SALEM ANIMAL HOSPITAL SITE DEVELOPMENT PLAN

NO.	COMMENTS	DATE
1	REMOVED 8" WATER MAIN & SCRE ACROSS WEST MAIN STREET AND FIRE HYDRANT.	06/15/2022

SHEET TITLE: UTILITY PLAN

SHEET NUMBER: C4-01

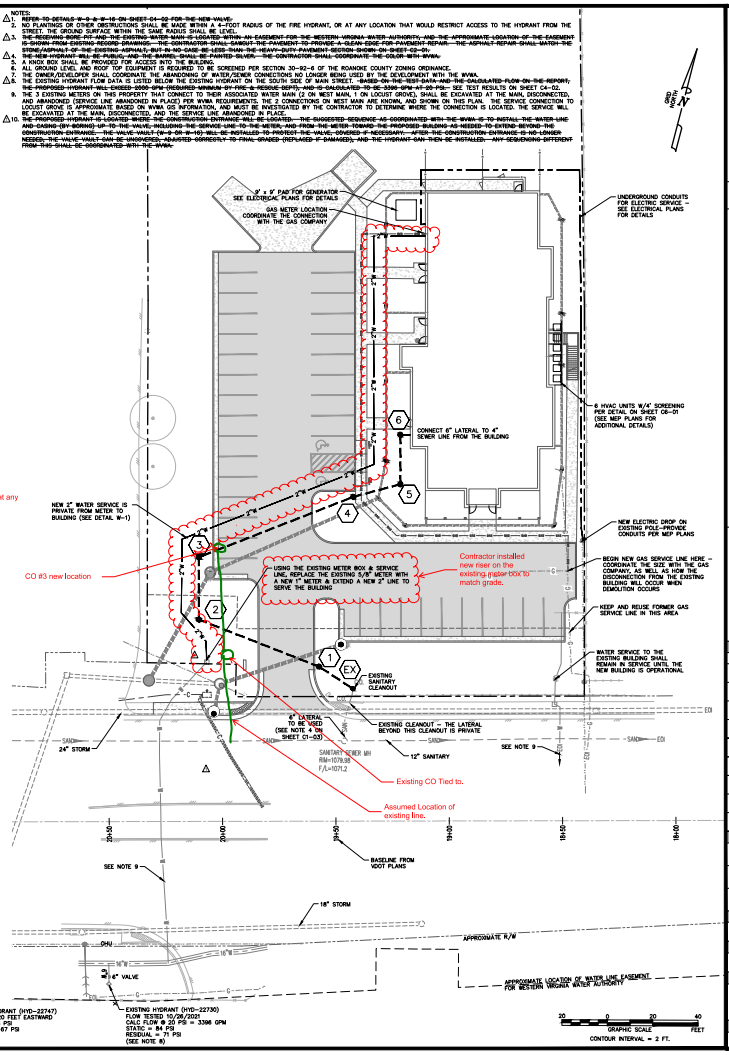
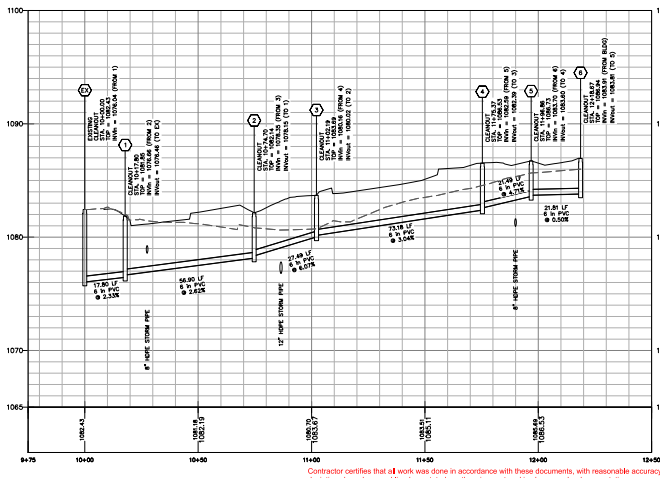
1. ~~REFER TO DETAILS W-3 & W-16 ON SHEET C4-02 FOR THE NEW VALVE.~~
2. NO PLANTINGS OR OTHER OBSTRUCTIONS SHALL BE MADE WITHIN A 4-FOOT RADIUS OF THE FIRE HYDRANT, OR AT ANY LOCATION THAT WOULD RESTRICT ACCESS TO THE HYDRANT FROM THE STREET. THE GROUND SURFACE WITHIN THE SAME RADIUS SHALL BE LEVEL.

3. ~~WHERE THE PROPOSED SERVICE LINE CROSSES THE WESTERN VIRGINIA WATER AUTHORITY AND THE APPROXIMATE LOCATION OF THE EASEMENT IS SHOWN FROM EXISTING RECORD DRAWING, THE CONTRACTOR SHALL SAWCUT THE PAVEMENT TO PROVIDE A CLEAN EDGE FOR PAVEMENT REPAIR. THE ASPHALT REPAIR SHALL MATCH THE STONE/ASPHALT OF THE EXISTING ASPHALT, BUT IN NO CASE BE LESS THAN THE HEAVY-DUTY PAVEMENT SECTION SHOWN ON SHEET C2-01.~~

4. ~~THE NEW HYDRANT WILL BE PURCHASED AND THE BARREL SHALL BE PAINTED SILVER. THE CONTRACTOR SHALL COORDINATE THE COLOR WITH WVWA.~~
5. A KNOX BOX SHALL BE PROVIDED FOR ACCESS INTO THE BUILDING.

8. ~~THE EXISTING HYDRANT FLOW DATA IS LISTED BELOW THE EXISTING HYDRANT ON THE SOUTH SIDE OF MAIN STREET. BASED ON THE TEST DATA AND THE CALCULATED FLOW ON THE REPORT, THE PROPOSED HYDRANT WILL EXCEED 2000 GPM (REQUIRED MINIMUM FIRE FLOW & RESIDUE DEPTH) AND IS CALCULATED TO BE 3306 GPM AT 20 PSI. SEE TEST RESULTS ON SHEET C4-02.~~

9. ~~THE 3 EXISTING METERS ON THIS PROPERTY THAT CONNECT TO THEIR ASSOCIATED WATER MAIN (2 ON WEST MAIN, 1 ON LOCUST GROVE), SHALL BE EXCAVATED AT THE MAIN, DISCONNECTED, AND ABANDONED. SERVICE LINE ABANDONMENT WILL FOLLOW WVWA REQUIREMENTS. THE 2 CONNECTIONS ON WEST MAIN ARE KNOWN, AND SHOWN ON THIS PLAN. THE SERVICE CONNECTION TO LOCUST GROVE IS UNKNOWN, AND WILL BE LOCATED BY THE CONTRACTOR TO DETERMINE WHERE THE CONNECTION IS LOCATED. THE SERVICE WILL BE EXCAVATED AT THE MAIN, DISCONNECTED, AND THE SERVICE LINE ABANDONED IN PLACE.~~

10. ~~THE PROPOSED HYDRANT IS LOCATED WHERE THE CONSTRUCTION ENTRANCE WILL BE LOCATED. THE SUGGESTED SEQUENCE AS COORDINATED WITH THE WVWA IS TO INSTALL THE WATER LINE AND CASING (BY BORING) UP TO THE VALVE, INCLUDING THE SERVICE LINE TO THE METER, AND FROM THE METER TOWARD THE BUILDING AS NEEDED TO EXTEND BEYOND THE CONSTRUCTION ENTRANCE. THE VALVE VAULT (W-3 OR W-16) WILL BE INSTALLED TO PROTECT THE VALVE, COVERED IF NECESSARY. AFTER THE CONSTRUCTION ENTRANCE IS NO LONGER NEEDED, THE VALVE VAULT CAN BE UNCOVERED, ADJUSTED CORRECTLY TO FINAL GRADE (REPLACED IF DAMAGED), AND THE HYDRANT CAN THEN BE INSTALLED. ANY SEQUENCING DIFFERENT FROM THIS SHALL BE COORDINATED WITH THE WVWA.~~
